Inquiry Report

Environment Effects Statement
Big Hill Mine Enhanced Development Project

16 September 2014

Report of Inquiry Panel pursuant to Section 9 of the Act

Figure 4: Predicted noise exposure of dwellings during most noisy quarters
 Source: Marshall Day Acoustics, presentation overheads, document number P3

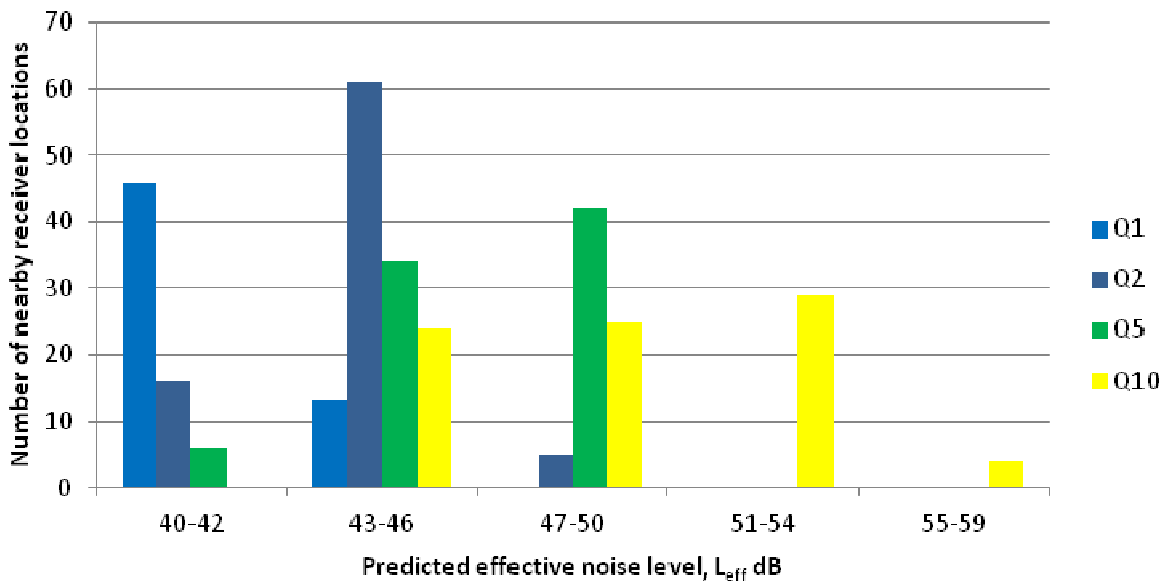
material benefit (perhaps 5-6dB) to residents, then this could be the subject of further community consultation prior to the Work Plan being finalised and works commencing.

Mr Delaire was further questioned by Dr Ferrando-Miguel as to why additional equipment noise mitigation packages, including those described in Appendix F of his expert witness statement, had not been applied. Mr Delaire responded that, as the noise emitted by different sources cannot simply be added to assess the effect on receptors, these measures might not have any effect on receptor noise levels (noise at a receptor would largely be the noise from the loudest source). It therefore would be necessary, he said, to identify any problem on the ground to determine what treatment would be effective and/or practicable. He said that, in some cases, equipment to achieve total compliance did not exist and other measures to mitigate impacts, such as architectural treatments to the housing, may be required.

Mr Power (document P87) noted that during the detailed design and equipment selection steps for the project, other opportunities to reduce noise emissions would need to be considered. He also noted that SGM accepted Mr Delaire's advice to the Panel that it would need to select the quietest equipment that is practicable and it also accepts the need for a more refined and granular level of acoustic modelling throughout the project life. He further stated that this would enable SGM, regulators and stakeholders to understand where and when the noise impacts of the project are likely to be greatest. This in turn would enable criteria to be developed and included in the Work Plan, community information provision and liaison to occur, and decisions to be made on application of acoustic treatment for dwellings and resident relocation.
